CONTROLLED DOCUMENT TRANSMITTAL

AFFECTED DOCUMENT: **IPEC EMERGENCY PLAN PROCEDURE**

|  Entergy | IPEC SITE EMERGENCY PLAN IMPLEMENTING PROCEDURE | NON-QUALITY RELATED PROCEDURE | IP-EP-320 | Revision 10 |

Revision to IP-EP-320, Radiological Field Monitoring, includes changes involving revised instructions for performing pre-operational equipment checks and additional grid location information for monitoring points.

F&J Model DF-AB-40L Air Sampler (Using Sampler Battery)

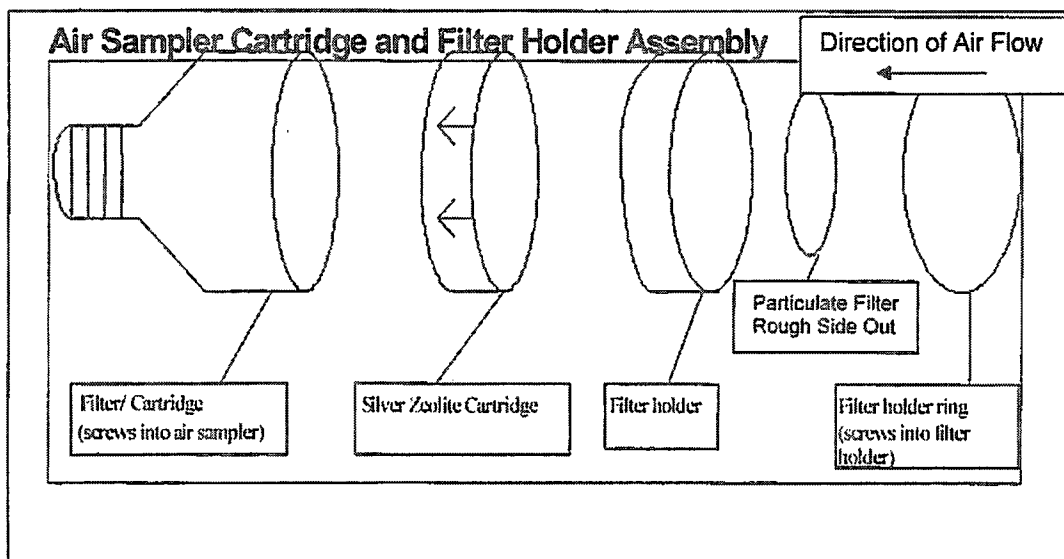
| <p>Change 10 - This is a training improvement item that clarifies the direction of air flow into the air sampler when positioning air sampling filters and cartridges. This change does not change the meaning or intent of a description, does not change facilities or equipment, and does not change a process related to a planning standard element due to the change more clearly depicting the direction of air flow when air sample holders are being loaded for use. No further evaluation is required.</p> | |

| 10. | Page 11 Attachment 2 Page 3 of 4 | No label stating "Direction of Air Flow" test box exists on diagram | Added "Direction of Air Flow" test box on diagram | NO | NO - This is a training improvement item that clarifies the direction of air flow into the air sampler when positioning air sampling filters and cartridges. This change does not change the meaning or intent of a description, does not change facilities or equipment, and does not change a process related to a planning standard element due to the change more clearly depicting the direction of air flow when air sample holders are being loaded for use. No further evaluation is required. |
